ADDENDUM NO. 1

Date November 9, 2023
Eugene School District 4J
Gilham Elementary School Roof Replacement 2024

Gilham Elementary School Roof Replacement 2024

ROOF PLAN - SECTOR D

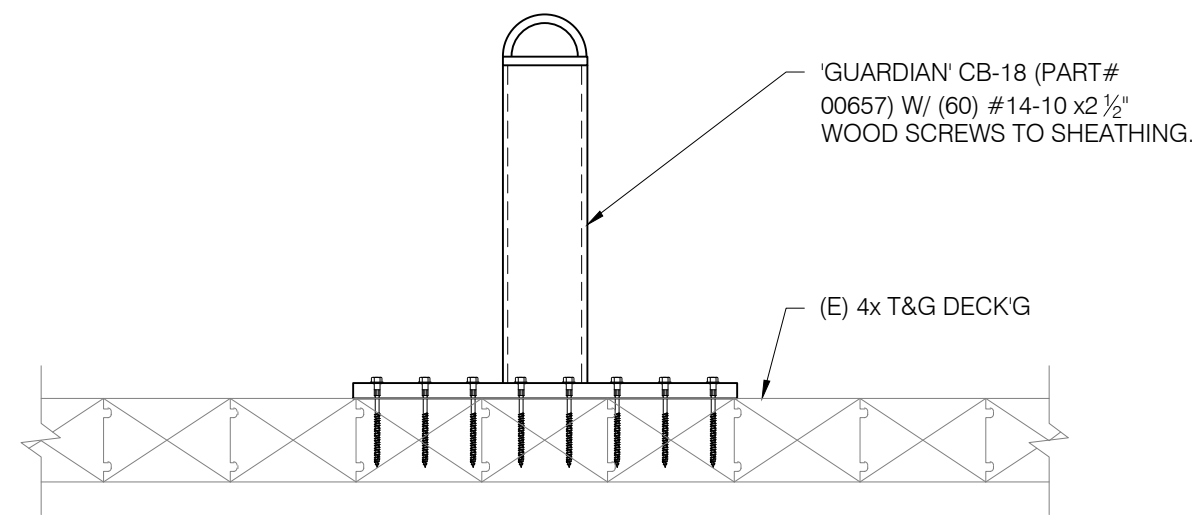
1.11	<i>Drawing Sheet S108</i>	Replace sheet with attached revised Sheet S108. Note the following changes: <ul style="list-style-type: none">• Added Addendum No. 1 revision identifier.• Quantified the number of beam repairs associated with key note #7. There are eight (8) locations total for the project.• Clarified key note and detail tags for fall protection.

Sheet Title:
ROOF FRAMING DETAILS

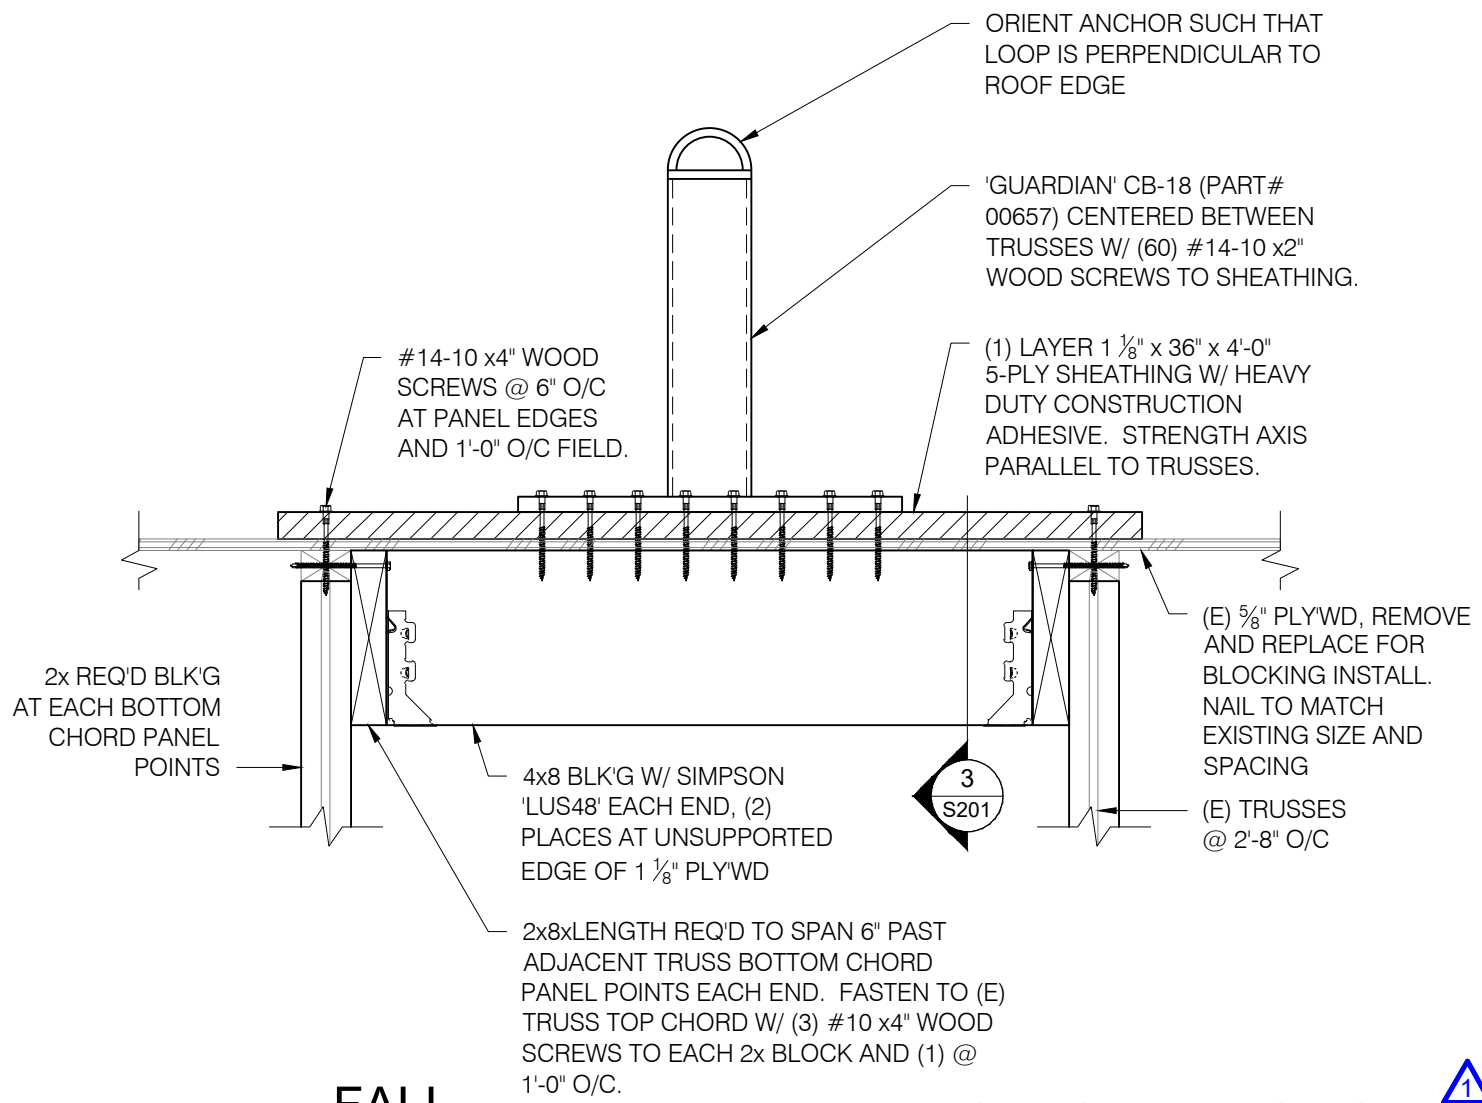
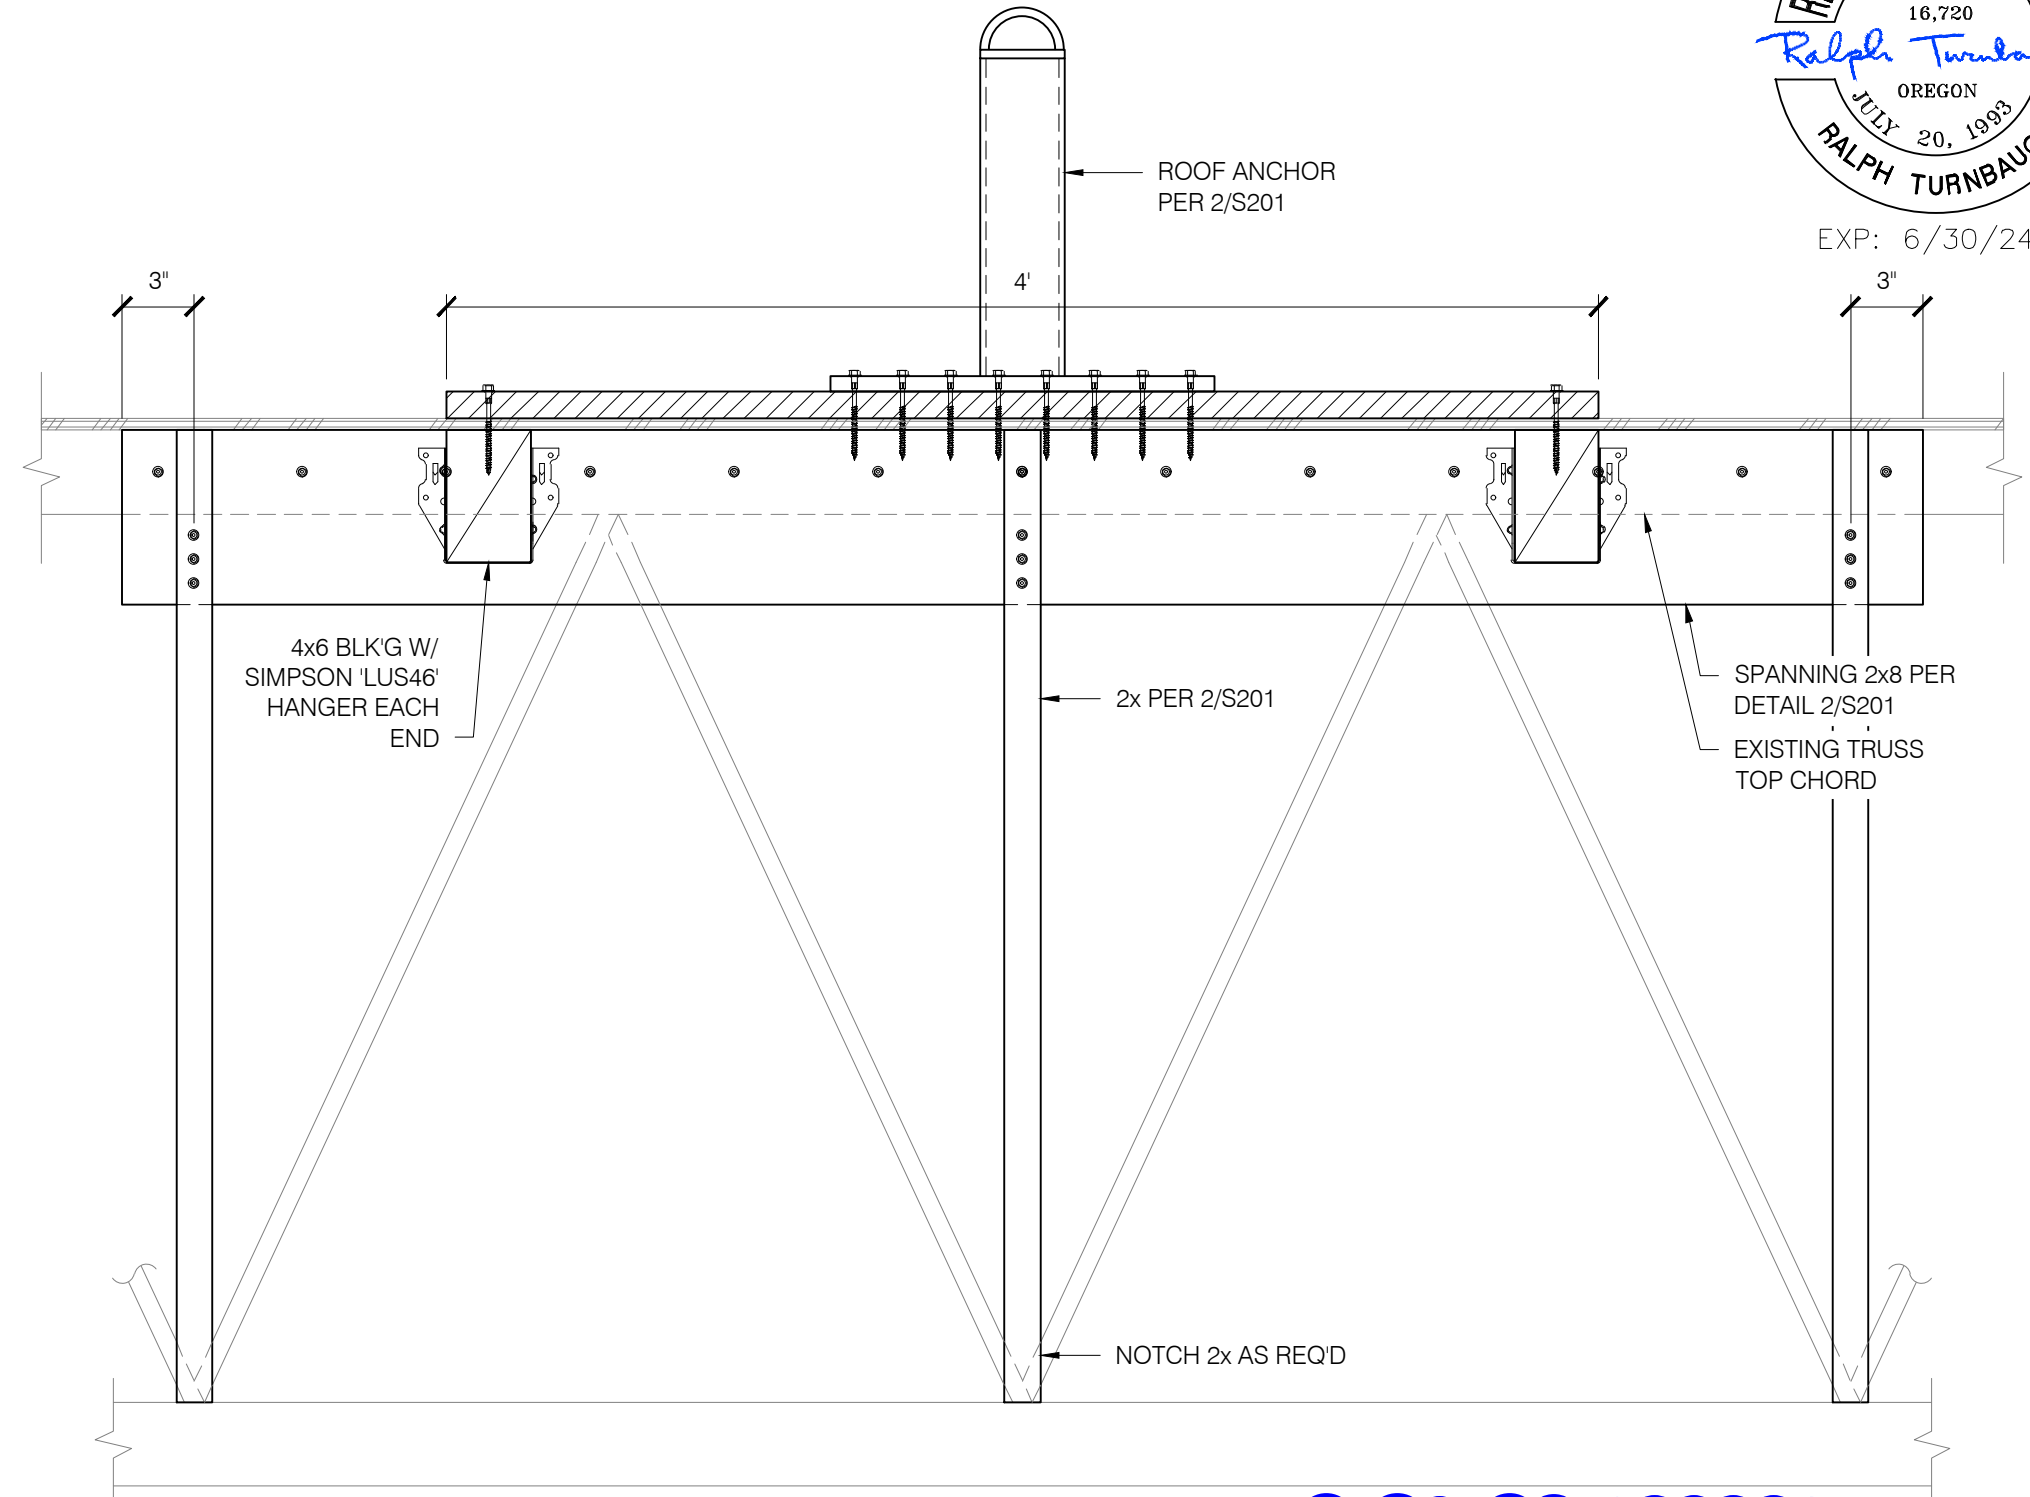
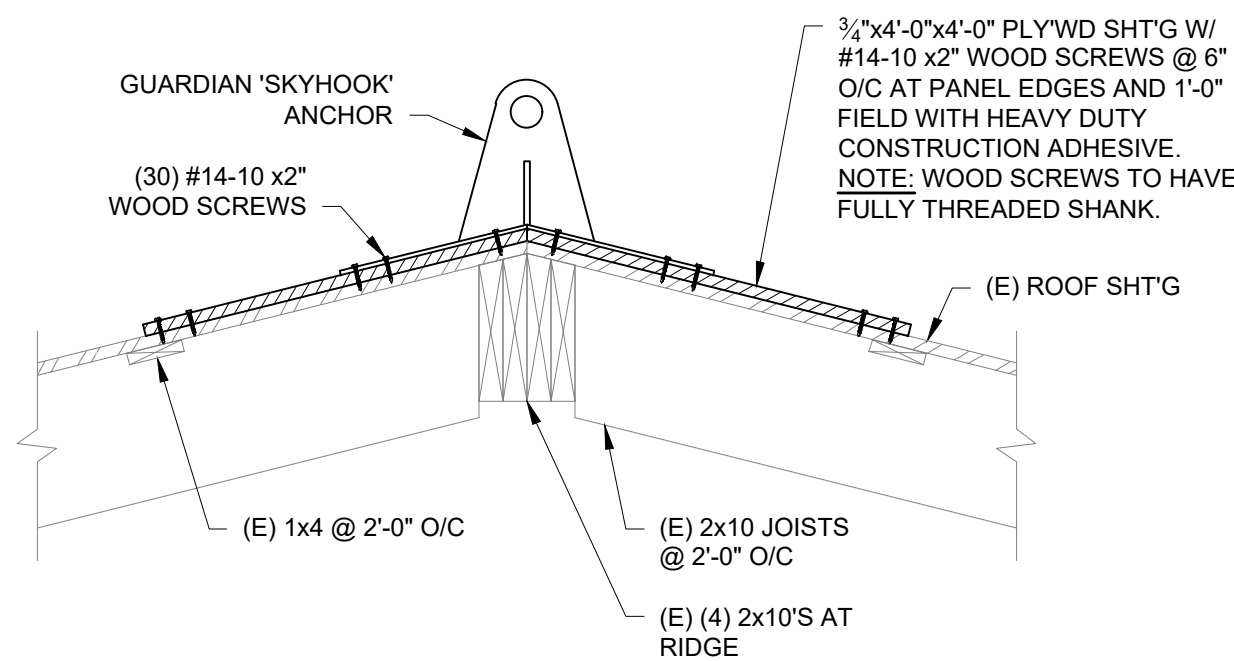
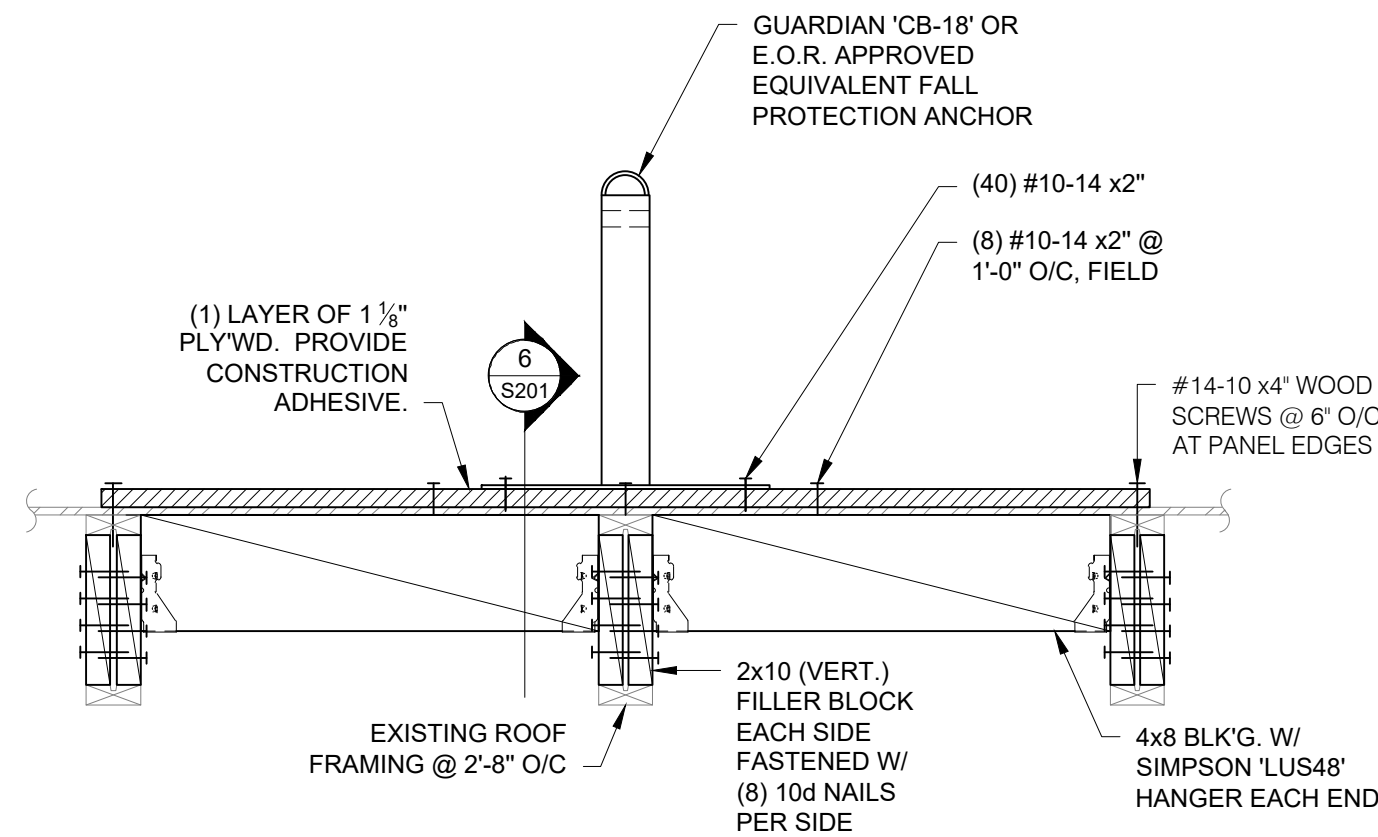
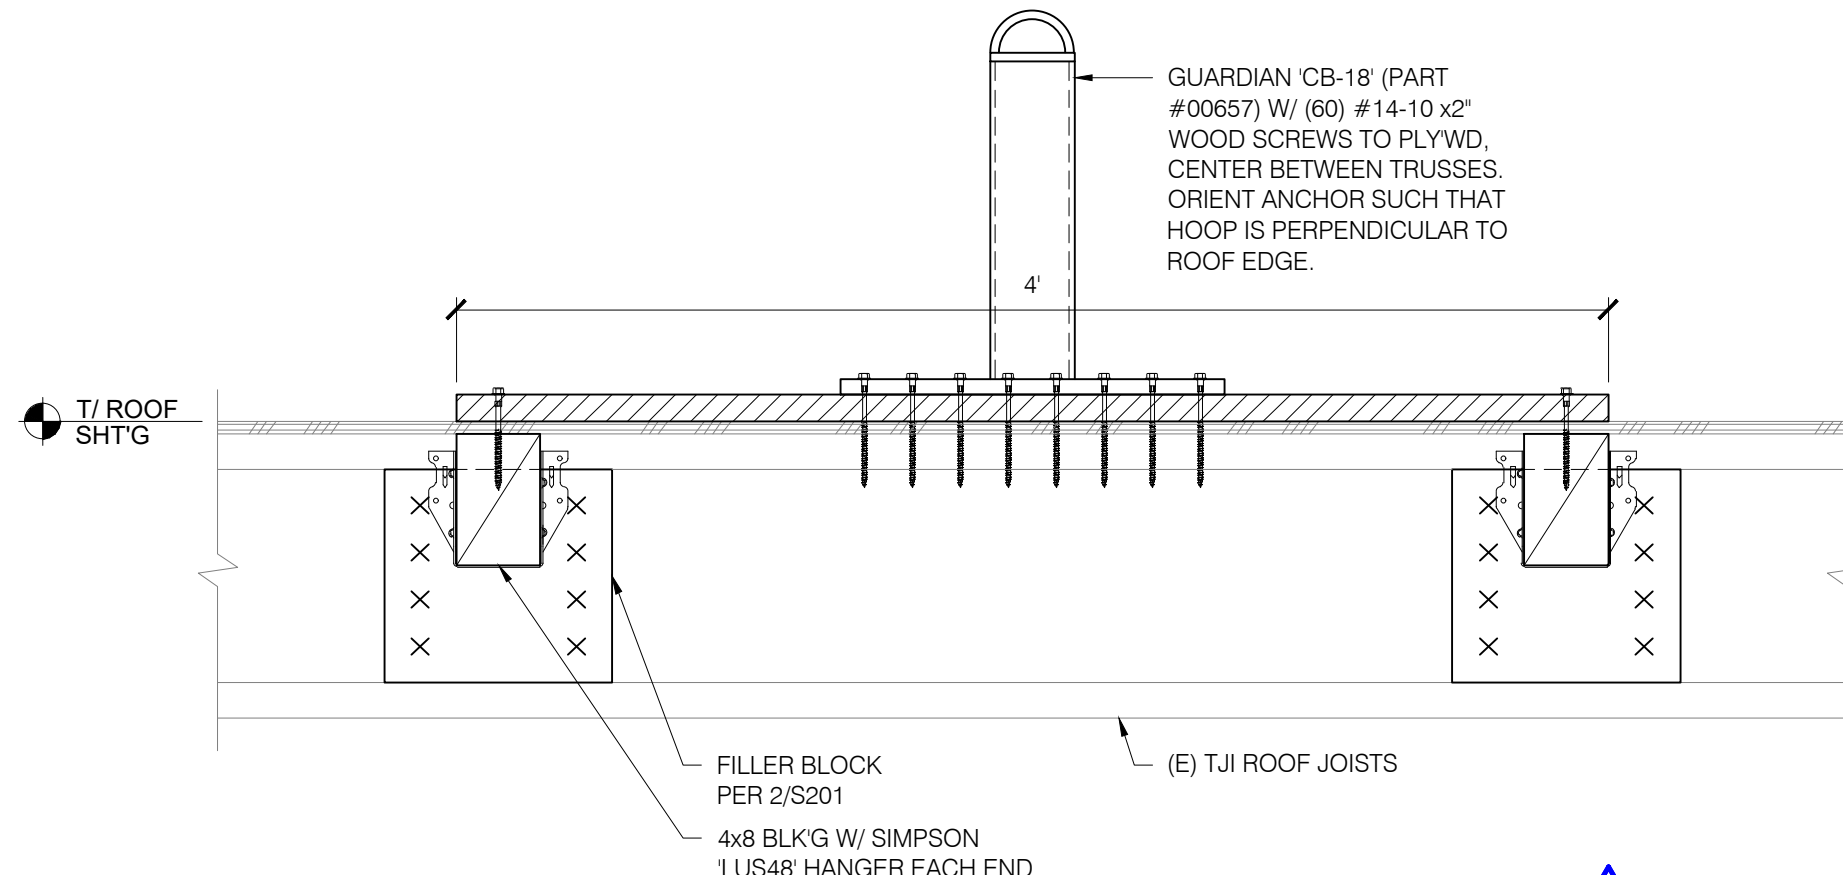
1.12	<i>Drawing Sheet S201</i>	Replace sheet with attached revised Sheet S201. Note the following changes: <ul style="list-style-type: none">• Added Addendum No. 1 revision identifier.• Clarified detail names.
